Bulletin No.: PIP5806B

PIP5806B Intermittent Extended Crank No Start And A Possible DTC P0341 Set

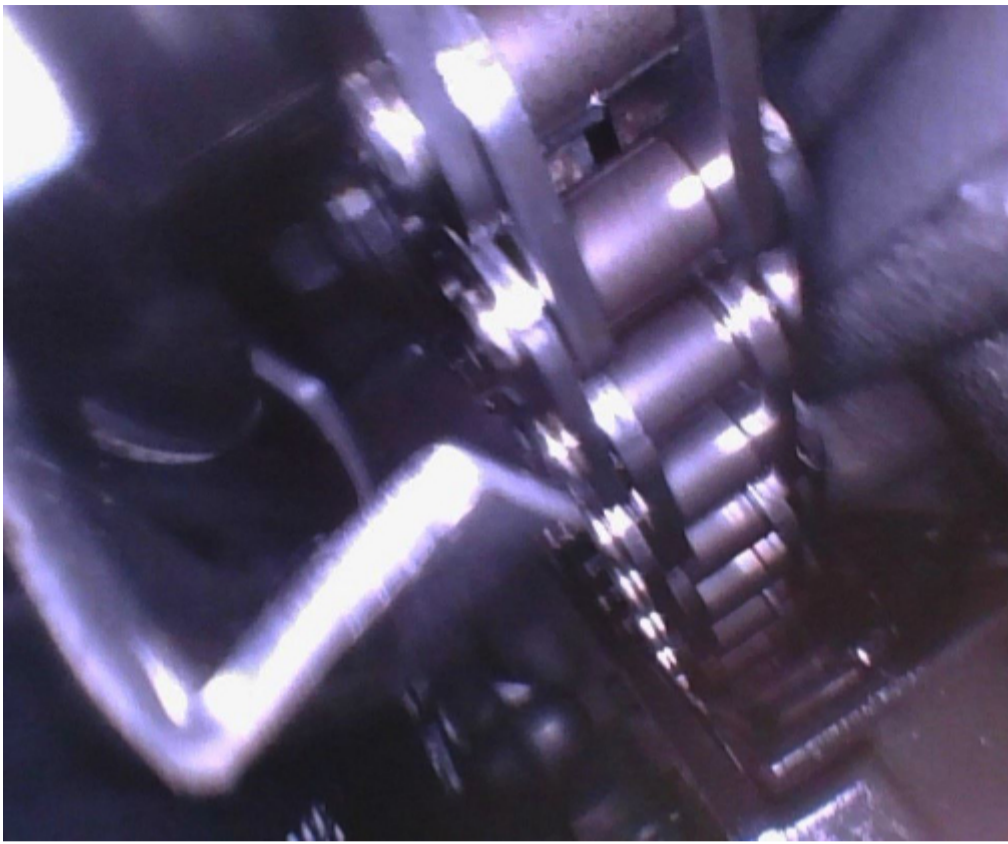
Involved Region or Country:	North America
Condition:	Some customers may experience an intermittent extended crank or intermittent crank/no start, and may find DTC P0341 set. The vehicle will crank until it times out. The vehicle will start on second attempt. Stop / Start system is not affected by this condition.
Cause:	This may be due to a corrupt signal from camshaft position sensor to ECM.

Carefully remove the camshaft position sensor and, using a borescope, inspect the camshaft trigger wheel coming into contact with the timing chain.

If the trigger wheel is coming into contact with the timing chain at any point, it will be necessary to replace the trigger wheel.

It will be necessary to roll the engine over by hand (up to two revolutions) to inspect each wheel segment. See the picture below:

Below are reference pictures of a good trigger wheel and chain:

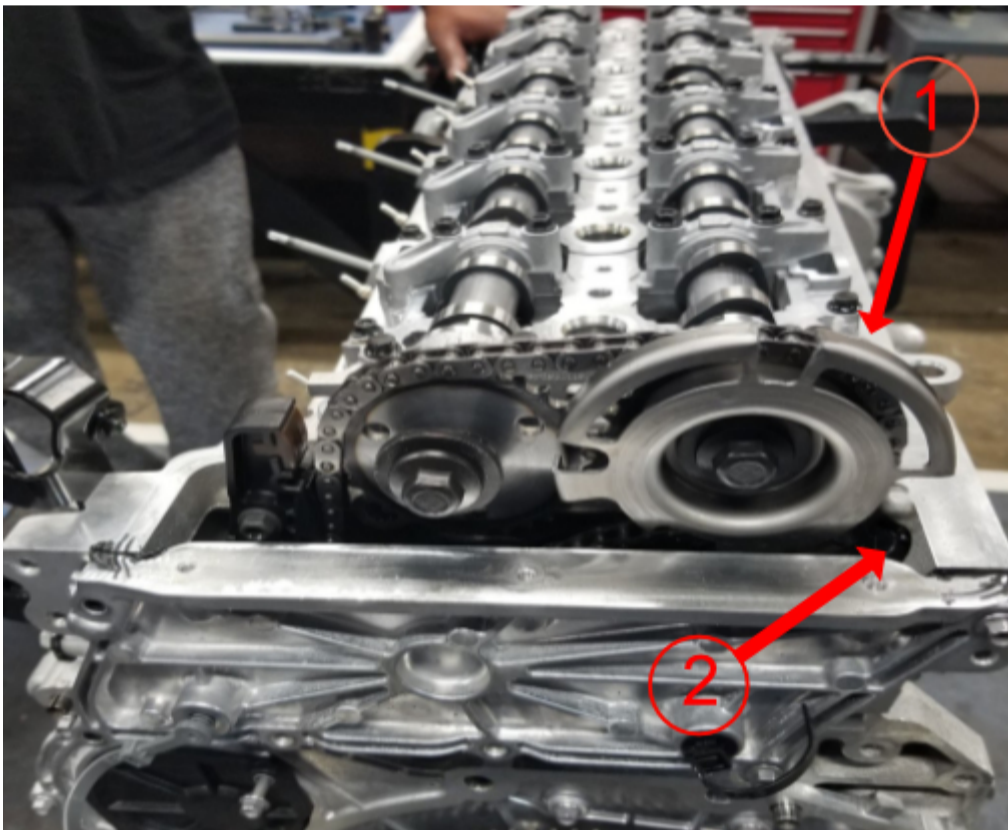
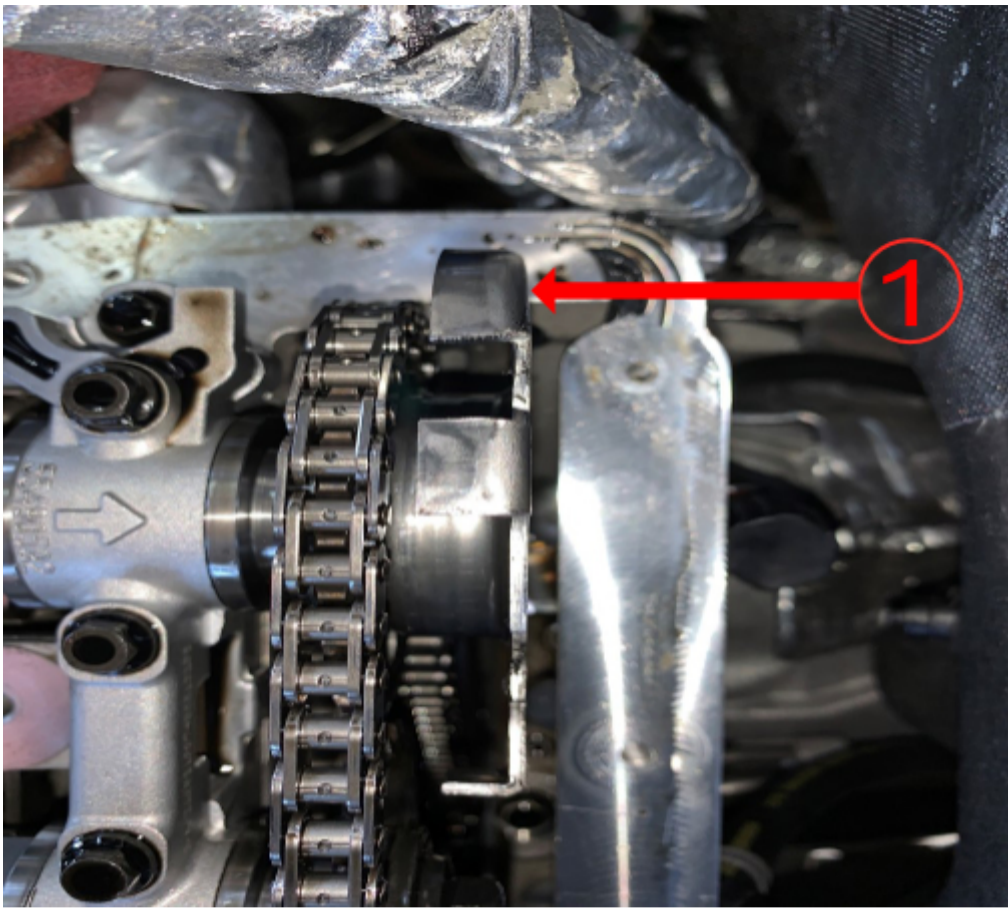
If the camshaft trigger wheel is not coming into contact with the timing chain at any point, Install a .5mm shim to the camshaft position sensor, p/n 12565102.
